RE: Proxy Cost Models for Universal Service

Response to US West/Sprint *Ex Parte* of April 4, 1997

This paper responds to criticisms of the Hatfield Model, Release 3.1 contained in a document entitled "Preliminary Review of the Hatfield 3.1 Model" by USWest, Sprint and INDETEC International, dated April 7, 1997.

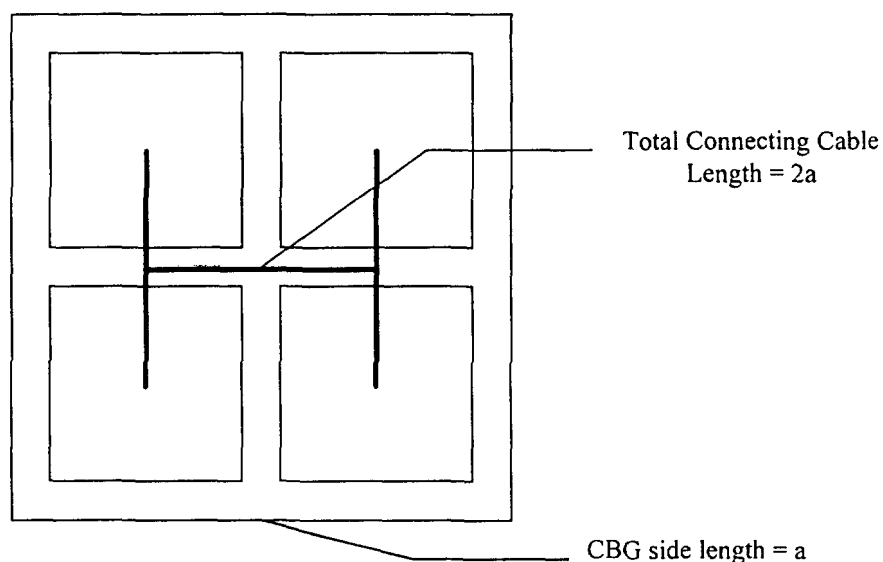
The BCPM sponsors claim that subfeeder cable is incorrectly omitted in cases where the main feeder route intersects the CBG boundary. This is incorrect.

The following cases assume a symmetric arrangement of CBGs above and below the nominal horizontal feeder route.

If the feeder route does not intersect the CBG, the model correctly computes subfeeder distance and investment.

If the feeder route intersects the CBG, three cases must be considered:

Case 1 -- feeder route coincides with the lower CBG boundary

required subfeeder cable distance = $1.5a$
 equipped connecting cable distance = $2a$
 overstatement of cable = $0.5a$
 (requires no connecting cable if subfeeders are run directly from the feeder cable to the center of each cluster)

Case 2 -- feeder route bisects the CBG

required subfeeder cable distance = 0
 equipped connecting cable distance = $2a$
 required connecting cable distance = $a (= 4 \times a/4)$
 overstatement of cable = a

Case 3 -- feeder route intersects CBG $\frac{1}{4}$ of the CBG length from the lower boundary (note that, under the symmetry assumption, this is the average case)

required subfeeder distance = a

(no connecting cables required if subfeeder extends from the feeder cable to the center of each cluster, two of which it already passes through)

equipped connecting cable distance = $2a$

overstatement of cable = a
